August 10, 2020

RE: **Lot 13 Block 9 Unit 22, S.A.D. 228**  
**Volcano Cliffs Subdivision**  
**6411 Petirrojo Rd. NW**  
**Grading and Drainage Plan**  
**Engineers Stamp Date 8/7/2020 Rev (D10D003Q13)**

SOLIS, JAVIER - G & D PLAN

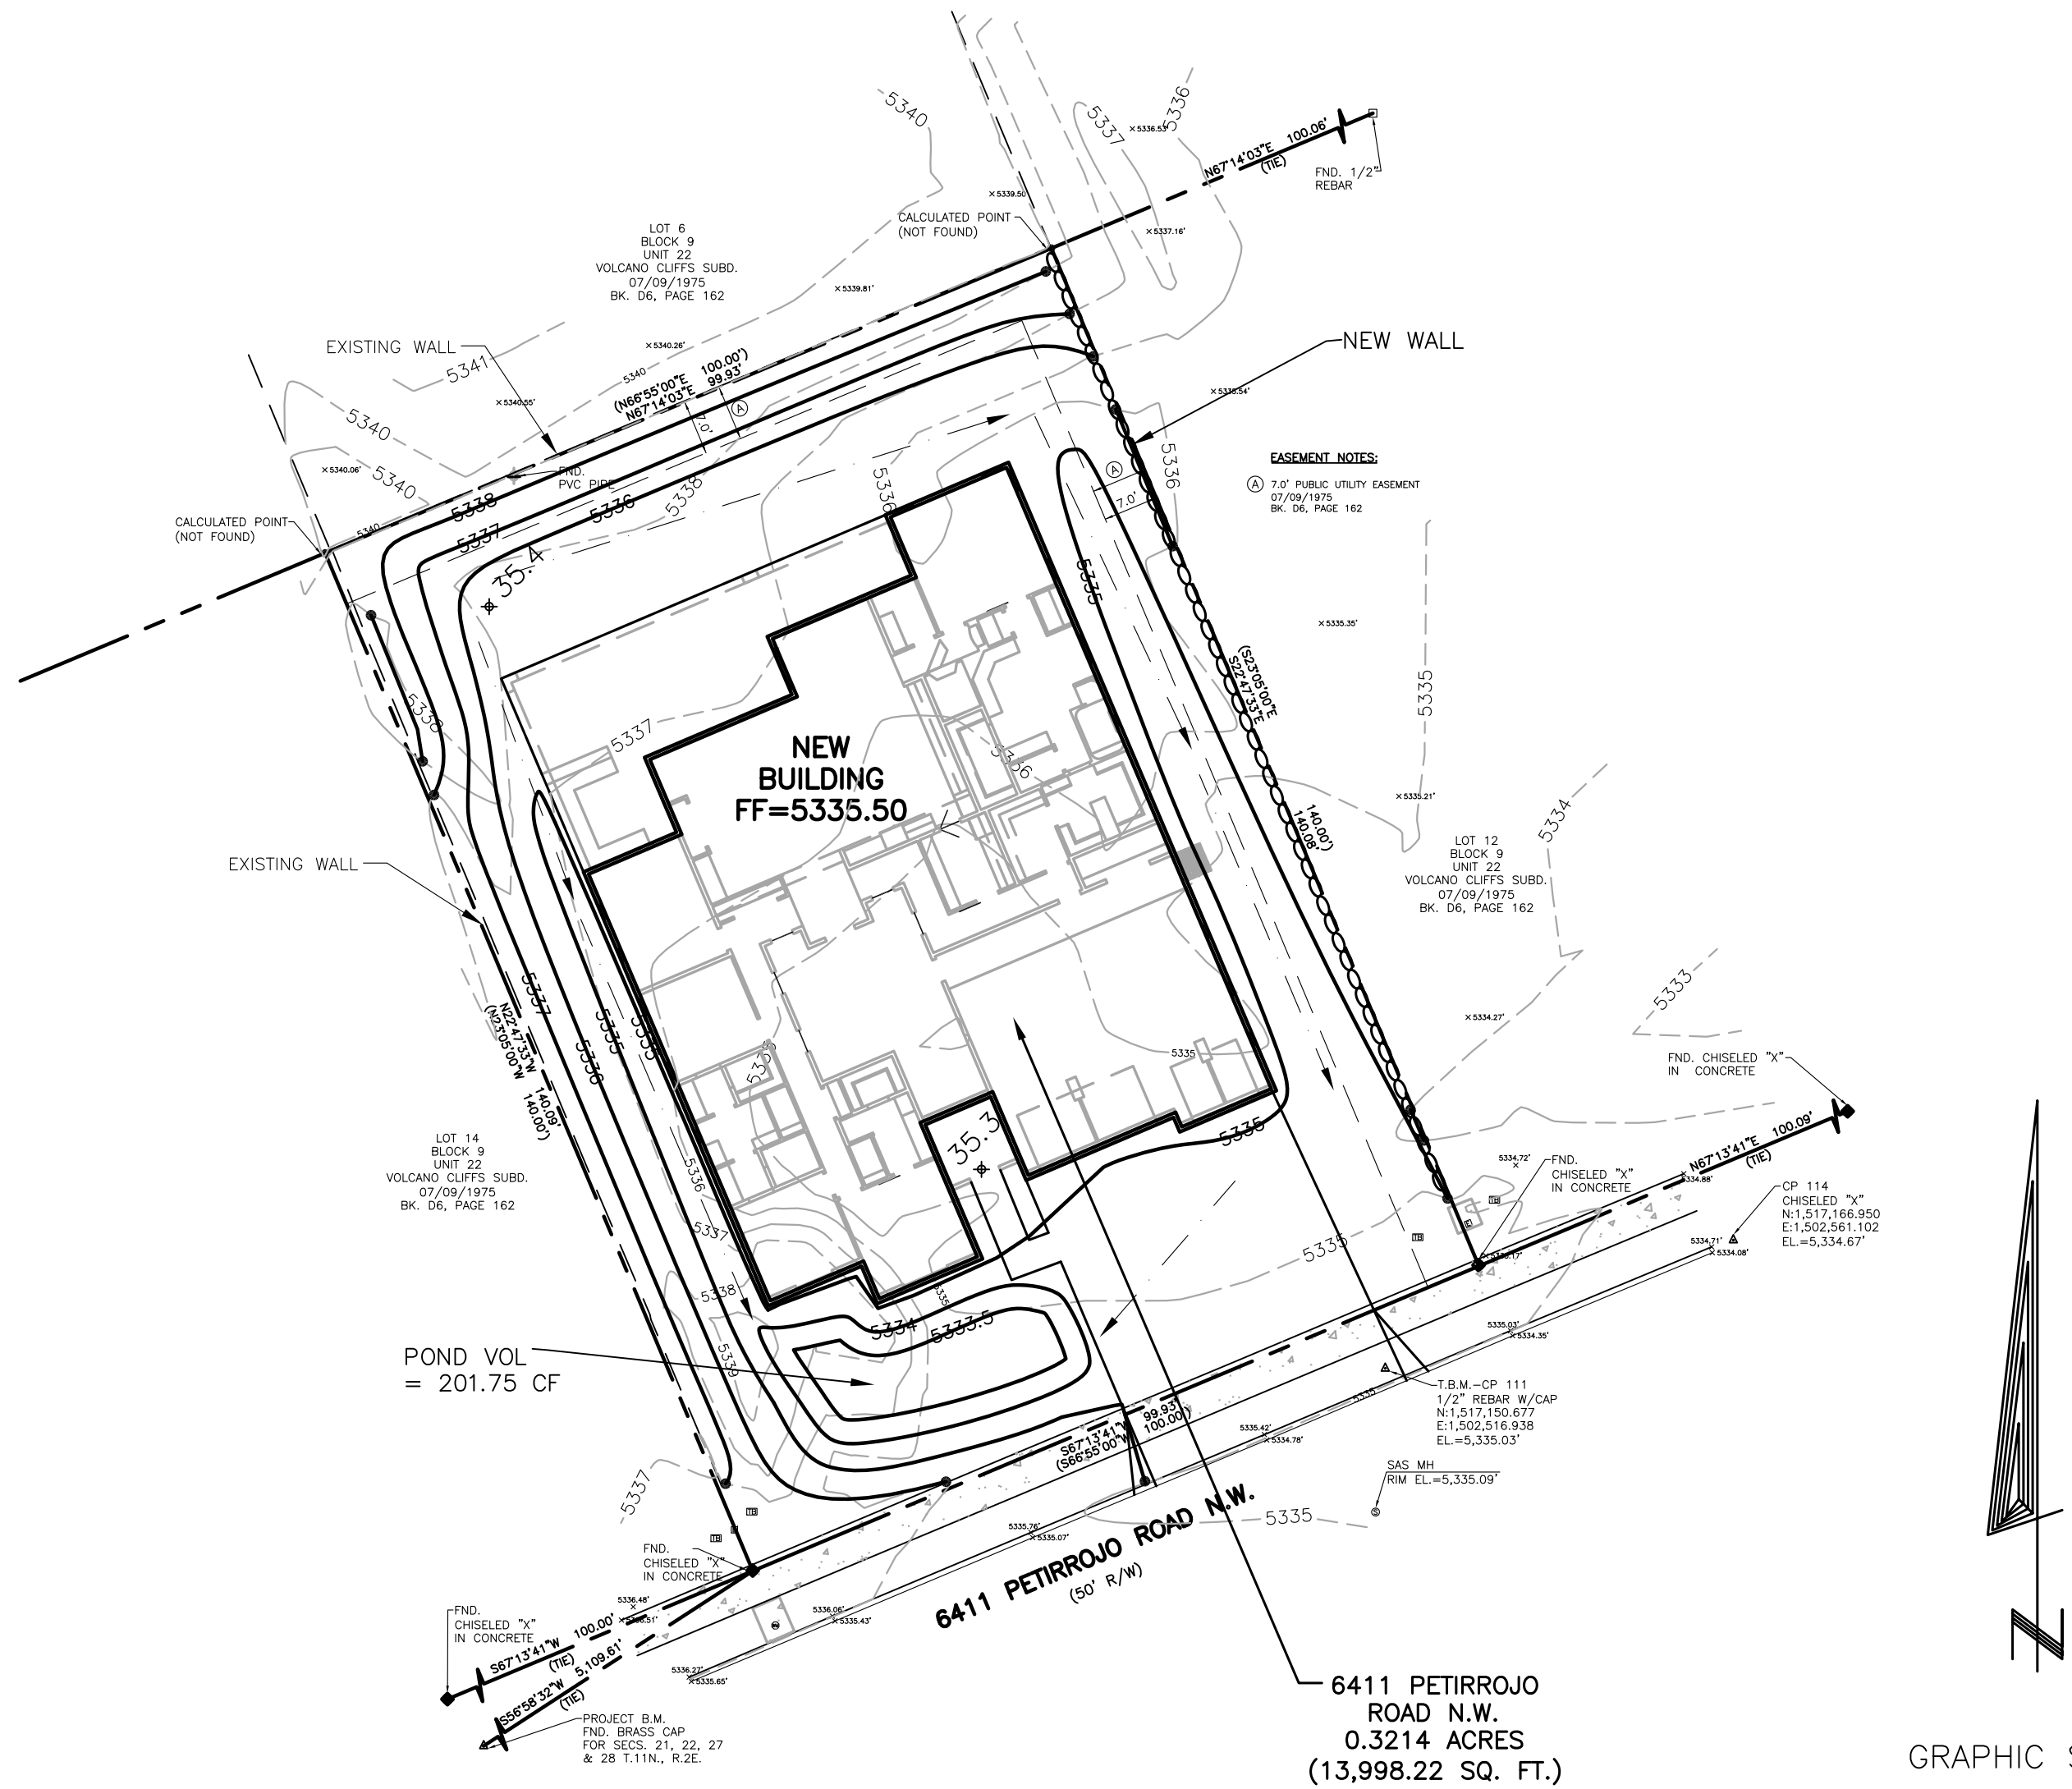
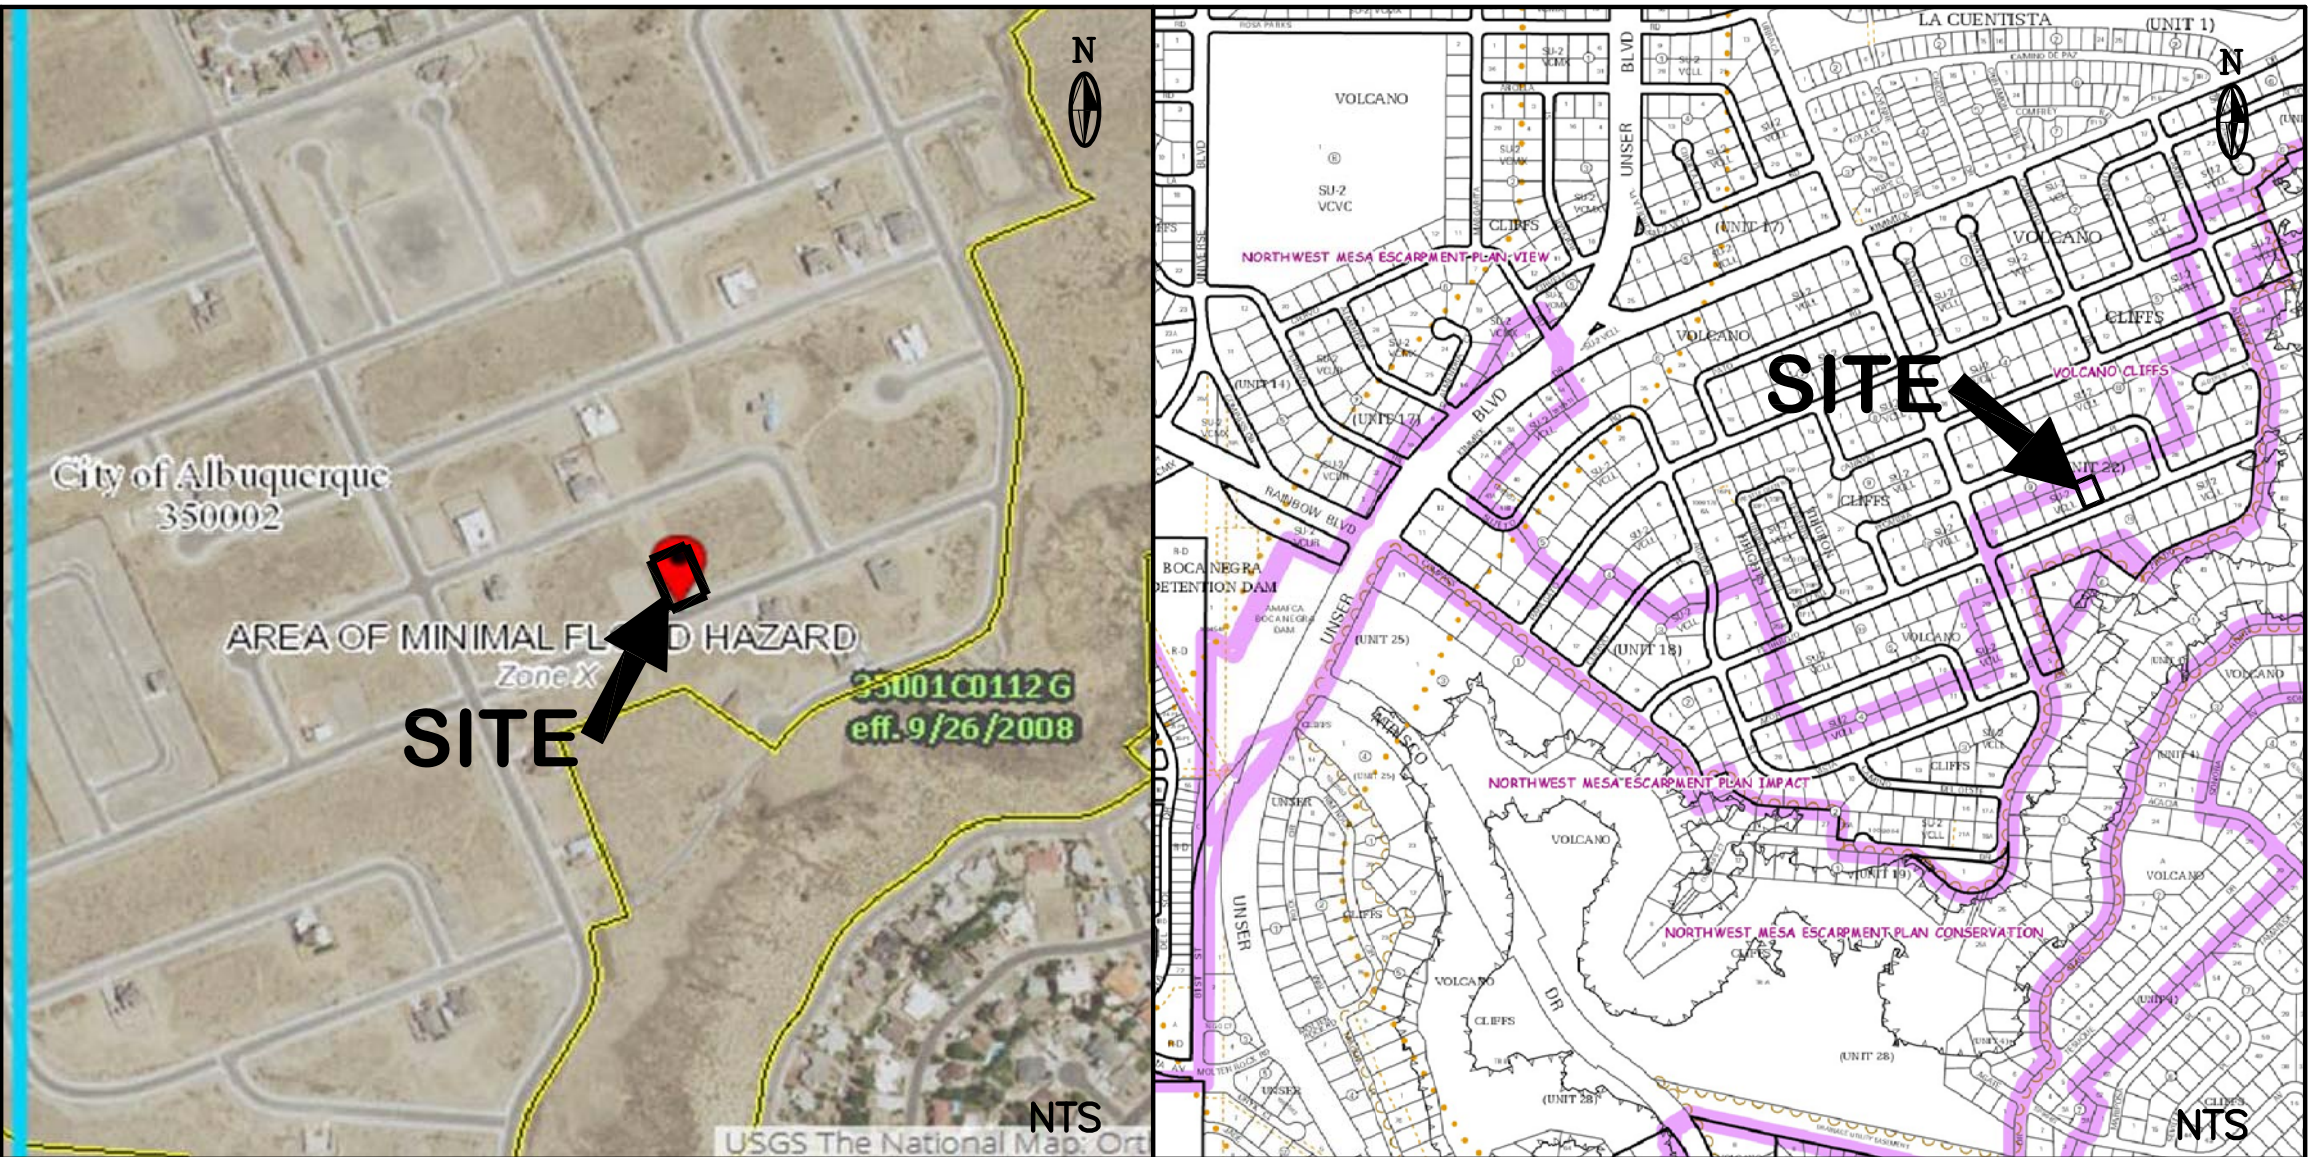
Based upon the information provided in your submittal received 8/7/2020, this plan is approved for Grading Permit.

**Prior to Building permit approval a Pad Certification will be required, provided by the Engineer or a registered Land Surveyor.**

Reiterate to the Owner/Contractor that a separate permit for a garden/retaining wall must be obtained, with the approved G&D plan dated 7/28/2020.

Prior to Certificate of Occupancy release, Engineer Certification per the DPM checklist of this plan will be required.

This is the plan to be used for any garden walls and any openings in the walls shall be placed 3" above final grade in the rear yard to allow for cross lot drainage from west to east (upstream to downstream).
